DEVELOPMENT APPLICATION ASSESSMENT REPORT

| Application Number: | DA2025/0140 |

| Land to be developed (Address): | Lot 10 DP 12609, 2 - 4 Kent Street COLLAROY NSW 2097 Lot 11 DP 12609, 2 - 4 Kent Street COLLAROY NSW 2097 |
| Proposed Development: | Alterations and additions to a dwelling house |

Figure 2: Area of encroachment illustrated in elevation form with existing built form to be retained represented in white, as well existing built form to be replaced represented in red dotted line

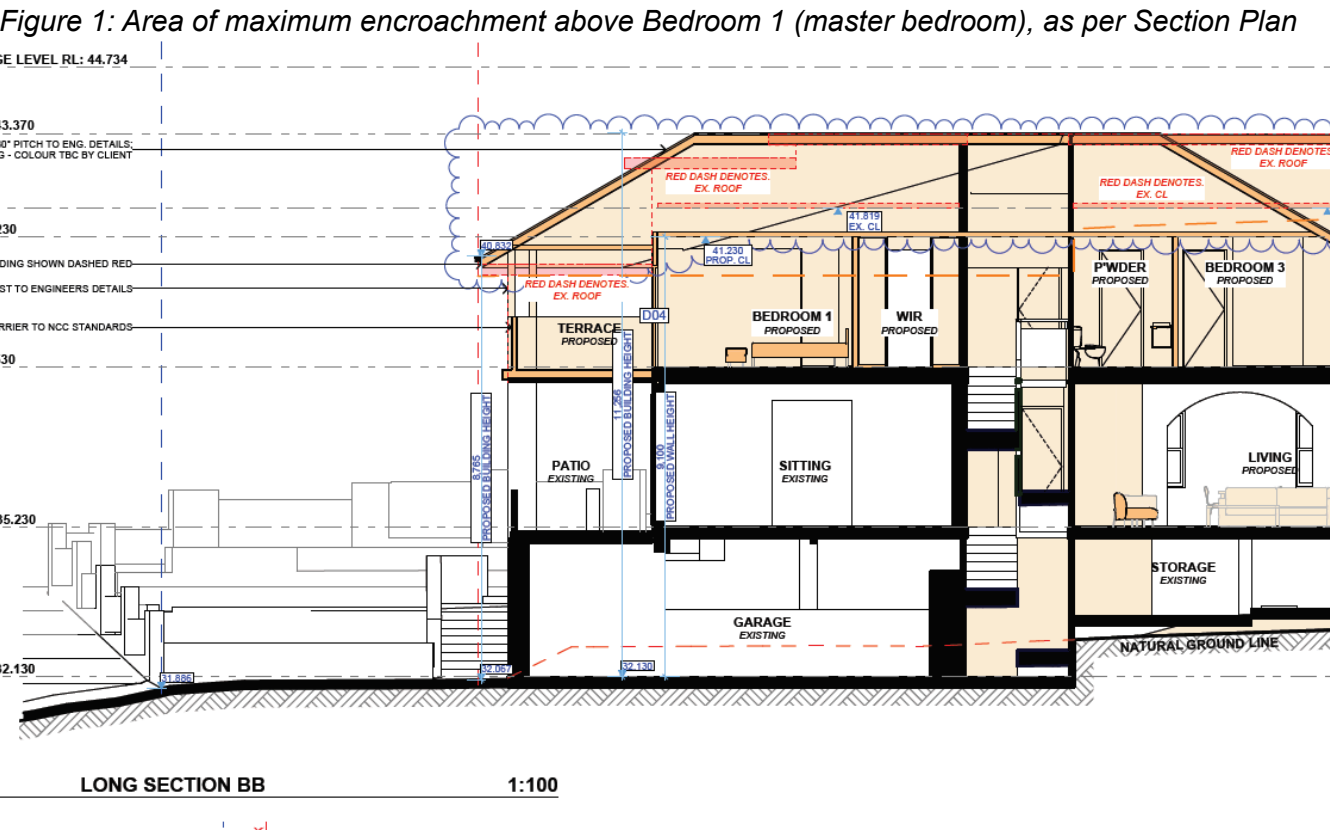
(a) The applicant's justification that the proposed non-compliance is a result of the existing approved dwelling house, is agreed with. This is demonstrated by the fact that the existing ridge line of the approved dwelling is being maintained and not exceeded at any point.

(b) The proposed first floor is generally sited within the overall envelope and footprint of the existing dwelling, whilst the section of the roof which extends above the master bedroom terrace incorporates a 'hipped' design to slope down with the topography of the land which falls towards the north-east of the site (see figures 1 and 2). The hipped roof design replaces the originally proposed gabled roof design which was amended during the assessment process to reduce the numerical encroachment as well as soften the extent of built form located beyond the prescribed standard.

(d) The proposed ceiling level is lower than the existing level to ensure the proposed the development fits predominantly within the existing footprint and envelope.

Figure 3: Site Plan with overlaid survey plan which shows topography of site sloping towards the north-east and below the first floor master bedroom

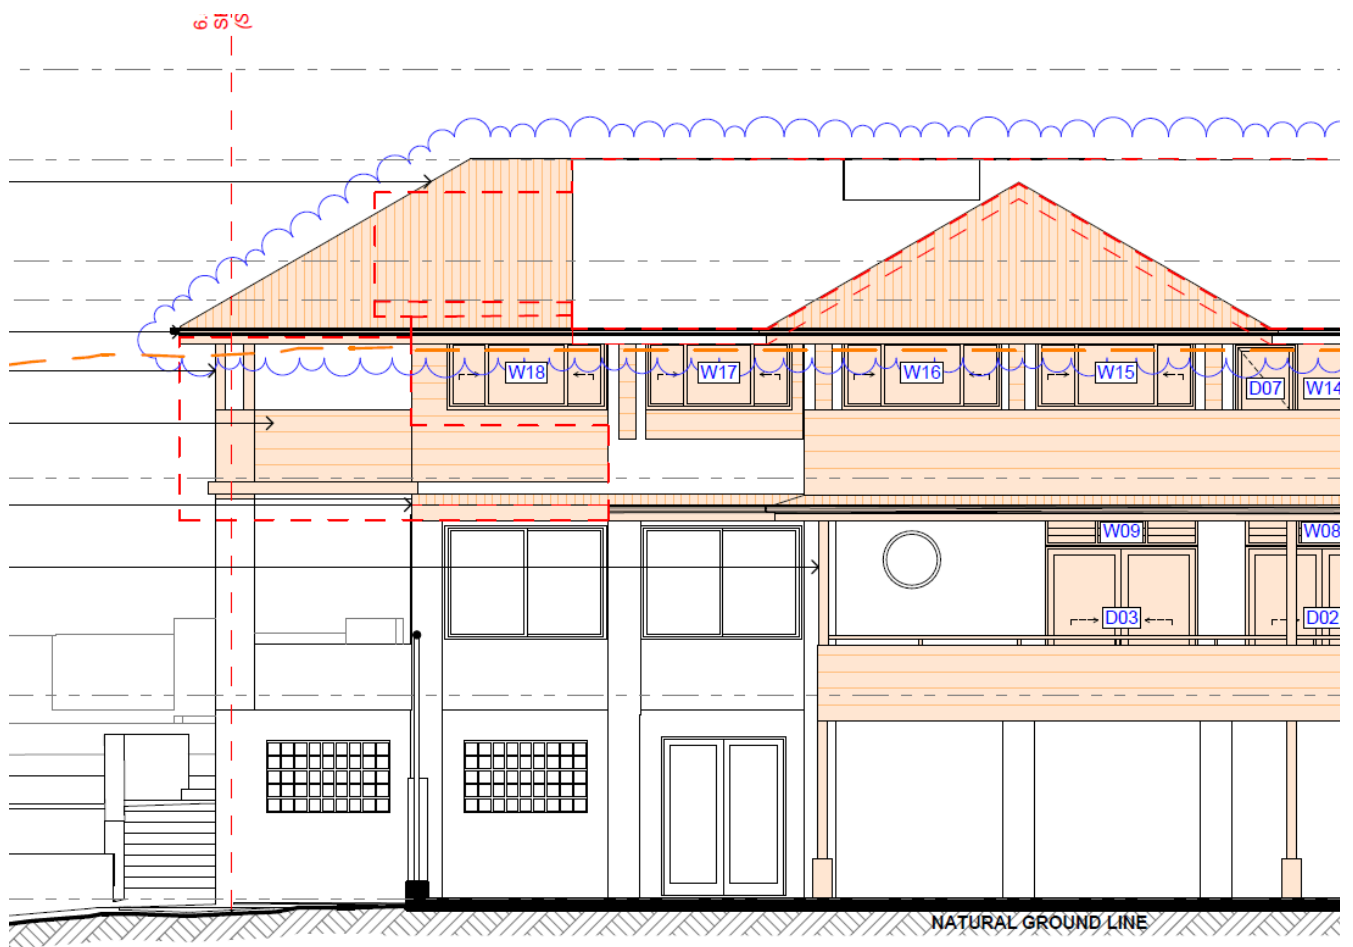
(e) The extent of numerical non-compliance is exacerbated by the existing lower ground floor which is located below the proposed ridge and which the proposed building height is measured from. The existing lower ground floor accommodates a garage and storage and is excavated below the natural extrapolated ground level of the site as shown in Figure 1.
